Carranstown Waste Management Facility

Waste Licence Application

Response in Accordance with Article 14 (2)(b)(ii) of Waste Management (Licensing) Regulations

**Indaver Ireland
Waste Management Facility, Carranstown, Duleek, Co. Meath.
(Waste Licence Reference 167-1)**

Proposed Construction Compound Car Parking and Access Layout

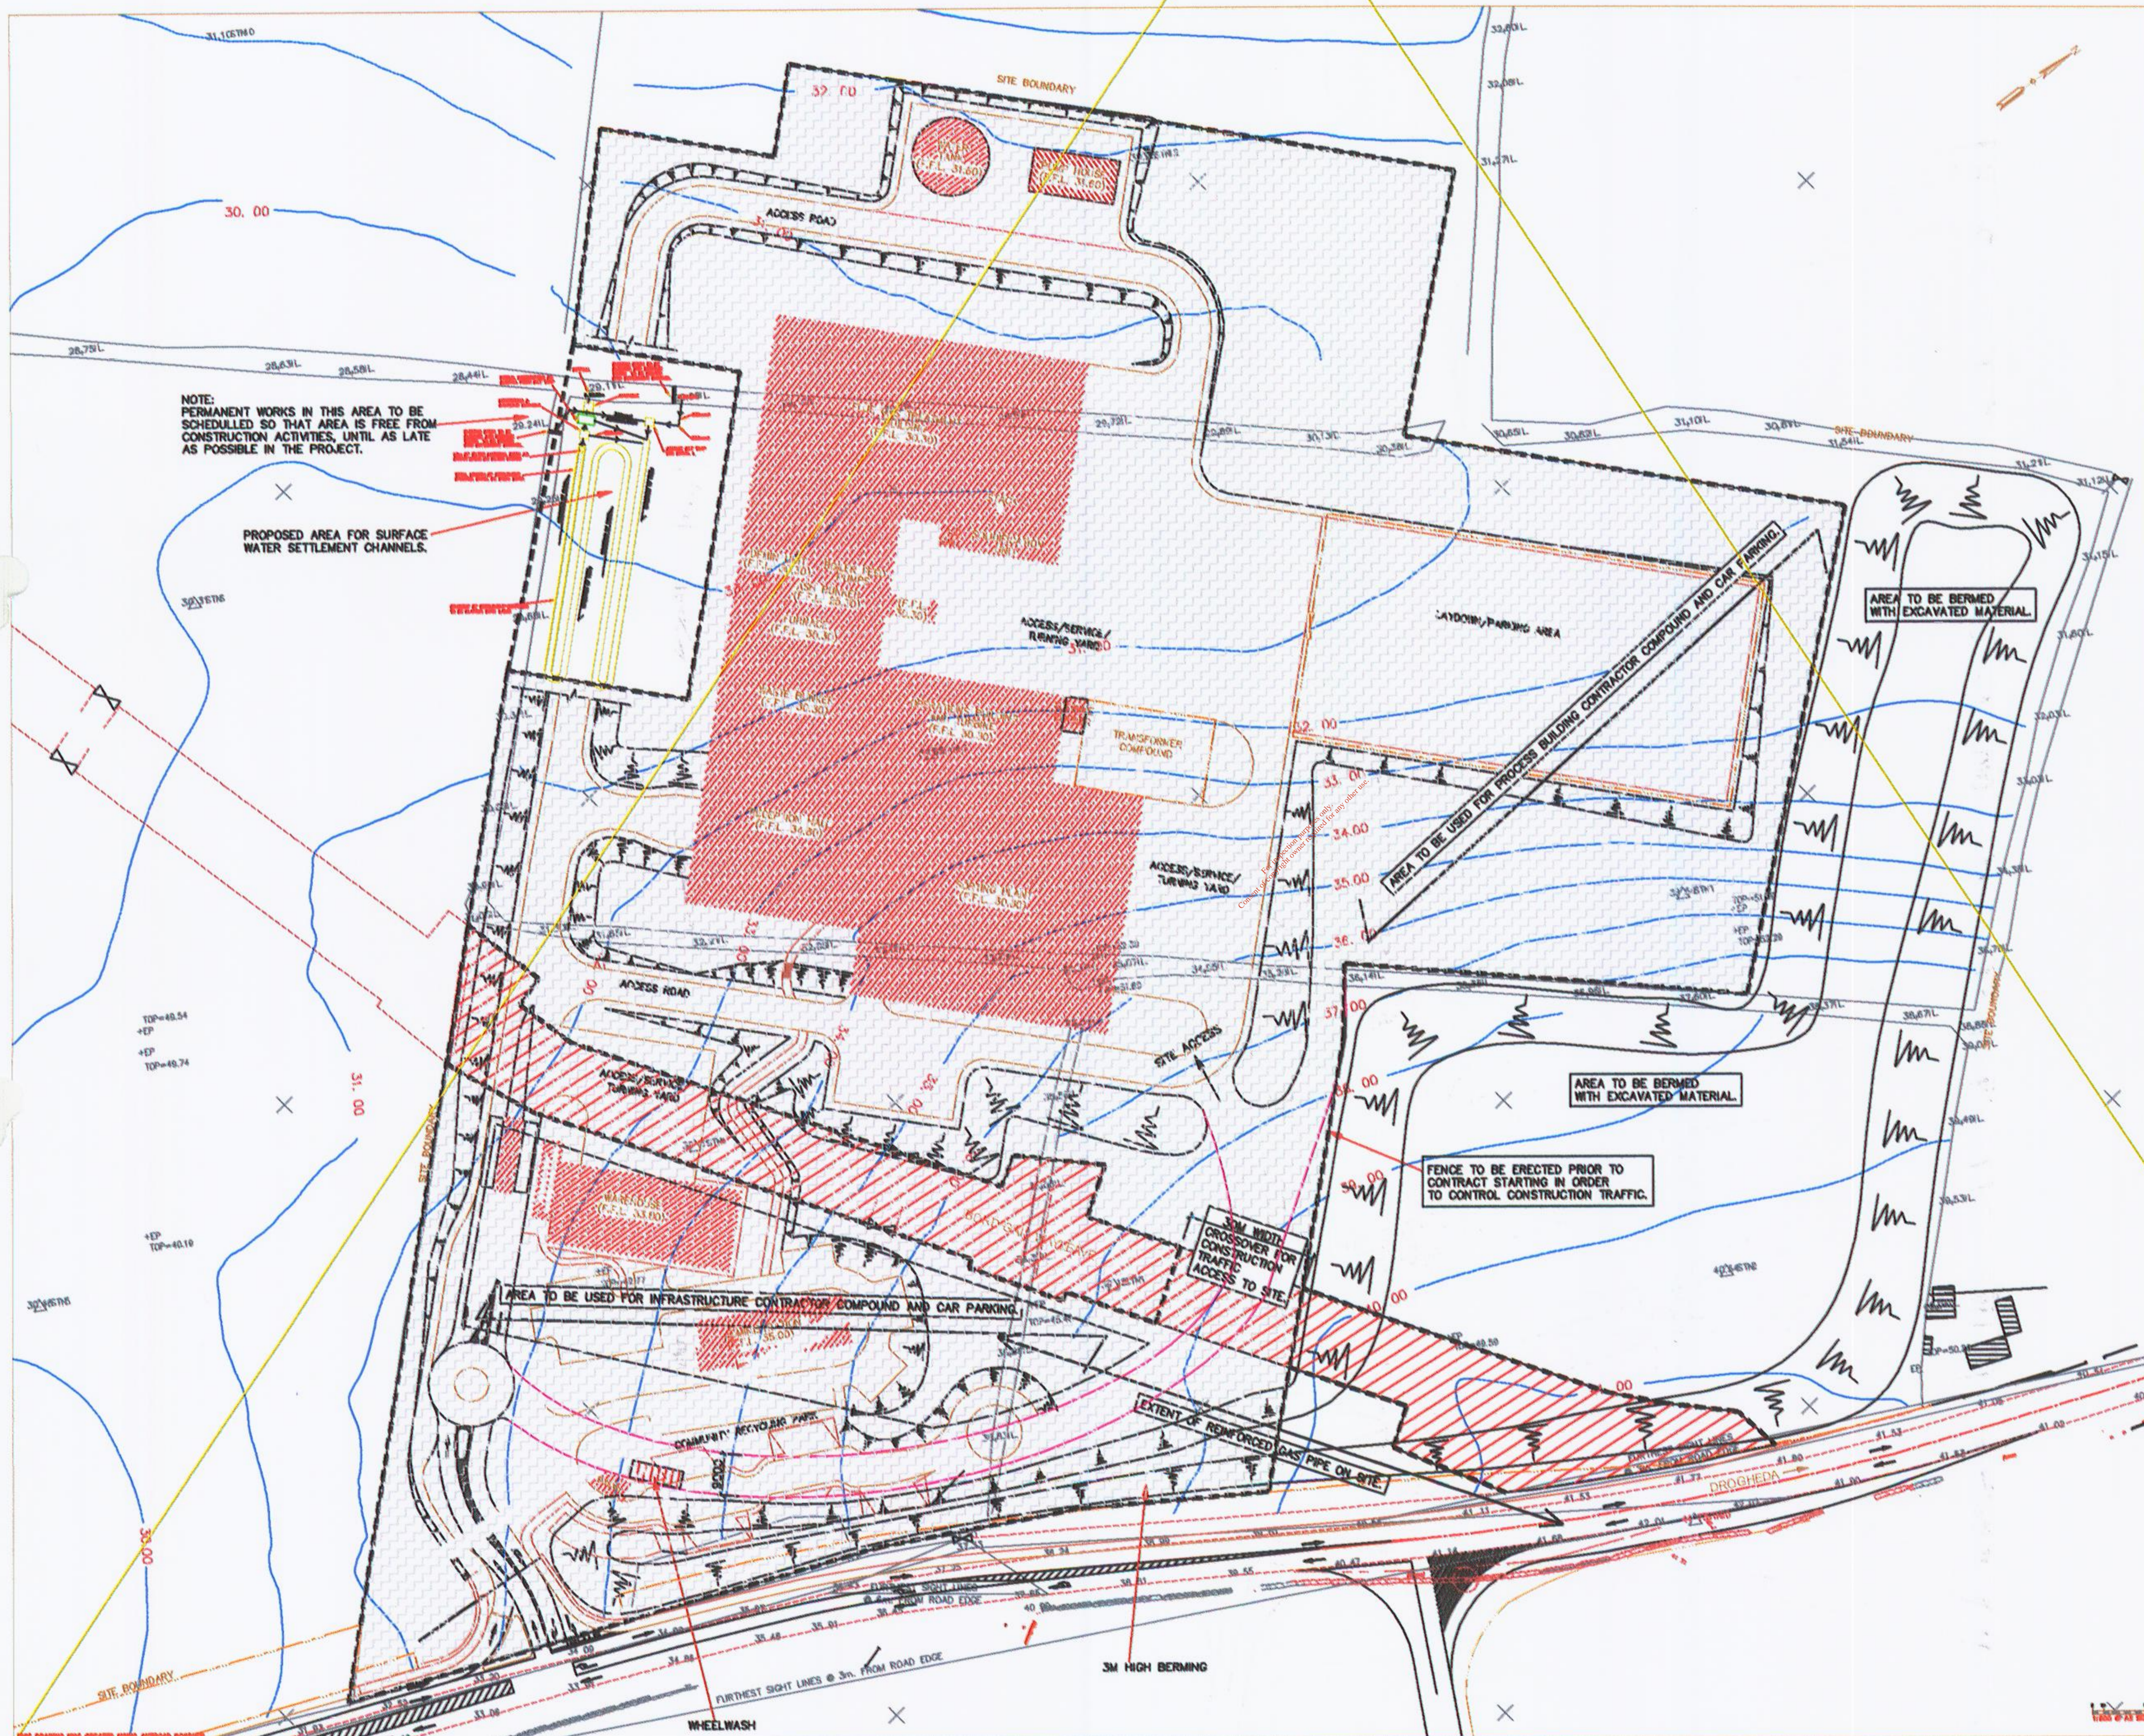
Regarding the wheel wash, which you propose to provide during facility construction, provide details of drainage arrangements.

It is proposed that a wheel wash be installed during facility construction as a control mechanism for the reduction of suspended solids within surface water discharges. The discharge from the wheel wash will be directed to the proposed settlement channels. The channels will work on the basis of reducing the velocity of the water instigating gravitational settlement of the suspended solids. The final 10-15m length of the channels will also incorporate additional filter material. The settlement channels will be regularly inspected and subsequently desilted by the site contractor. The discharge from the settlement channel will be directed through an oil interceptor prior to discharge to the drainage network.

PROPOSED AREA FOR SURFACE WATER SETTLEMENT CHANNELS.
